Wairau Blue-Green Network Stage 1 - A F Thomas Park

# Concept Feasibility Report - Appendices C to G

Revision 1 | 06 August 2025

Subject: AF Thomas Park Concept Options Technical Assessment

Figure 2: Output of mounding between drains calculation (by WSP)

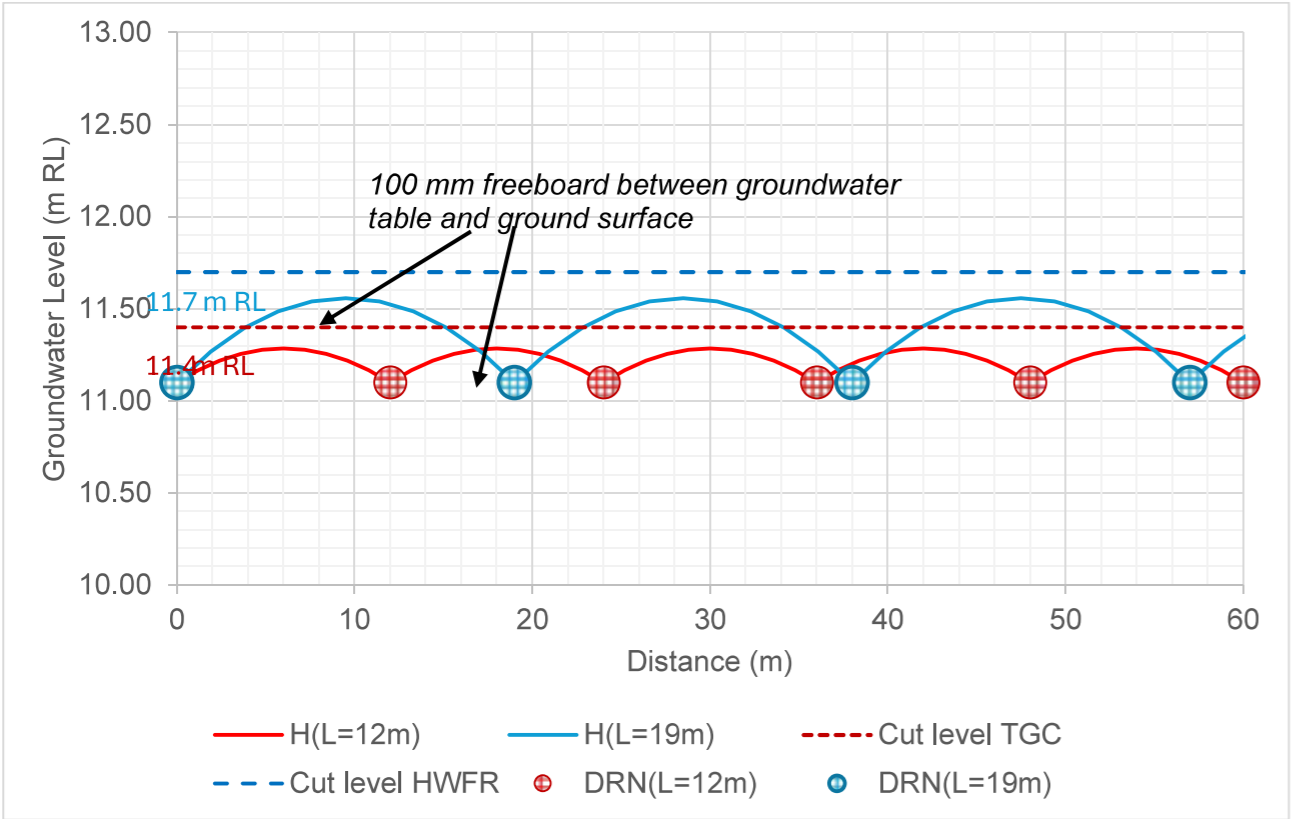
while the TGC would need drains every 12 m (Figure 2). It is important to note that this assumes the drains are equally effective between designs. However, the shallow fall of the TGC drains means these might be less effective, meaning that even more will be needed.

It should be noted this assessment is, by necessity, a simplification. At the upstream end of each proposal it is likely that increased density of drains will be needed as they will be shallower in these areas.
